Access Compliance Report

Public Rights-of-Way

Intersection ID: 10541	Main Street: CANTON_PL	Cross Street: POLK_ST	Location:	N
ADA ID: E0103CB110C2	Ramp Type: Perp	Initial Pass/Fail: Fail	Overall Compliance: No	Severity Score: 25
Codes/Mitigation Info/Possible Solution		Field Measurements/Component Compliance

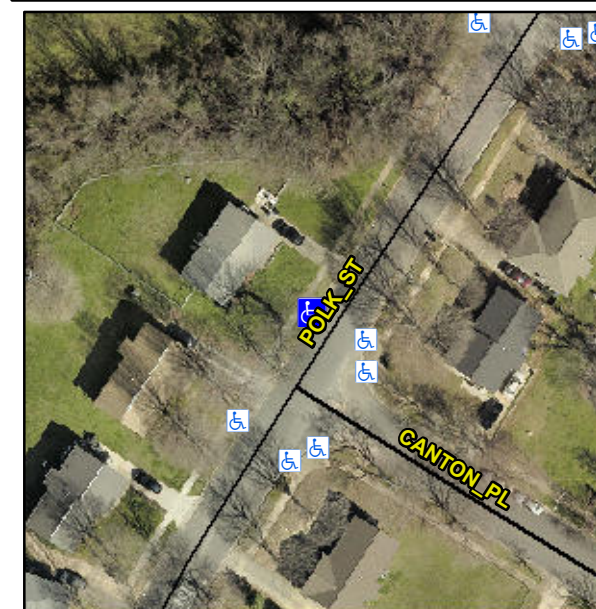
Not Found, R304.2.2

Compliance	Description	Data	Compliance	Description	Data
N/A	Ramp Length (in)	64.0	No	Ramp Slope (%)	12.9
Yes	Ramp Width (in)	49.0	Yes	Ramp XSlope (%)	1.5
N/A	Flare Type LT	N/A	N/A	Flare Type RT	N/A
N/A	Flare Slope LT (%)	N/A	N/A	Flare Slope RT (%)	N/A
N/A	Flare Traversable LT?	N/A	N/A	Flare Traversable RT?	N/A
N/A	Landing Length (in)	N/A	N/A	DWS Provided?	N/A
N/A	Landing Width (in)	N/A	N/A	DWS Contrast?	N/A
N/A	Landing Slope (%)	N/A	N/A	DWS Length (in)	N/A
N/A	Landing X Slope (%)	N/A	N/A	DWS Full Width?	N/A
N/A	Landing Curb? (Y/N)	N/A	N/A	DWS Offset (in)	N/A
N/A	Shared Landing?	N/A			
N/A	Gutter Ponding?	N/A	N/A	Gutter Slope (%)	N/A
N/A	Gutter Lip Ht (in)	1.0	N/A	Gutter X Slope (%)	N/A
N/A	Painted X Walk1?	No	N/A	Painted X Walk2?	N/A
	X Walk 1 Direction	To SE		X Walk 2 Direction	N/A
N/A	X Walk 1 Width (in)	N/A	N/A	X Walk 2 Width (in)	N/A
	X Walk 1 Slope (%)	1.4		X Walk 2 Slope (%)	N/A
	X Walk 1 X Slope (%)	1.8		X Walk 2 X Slope (%)	N/A

Remove & Replace Entire Ramp.
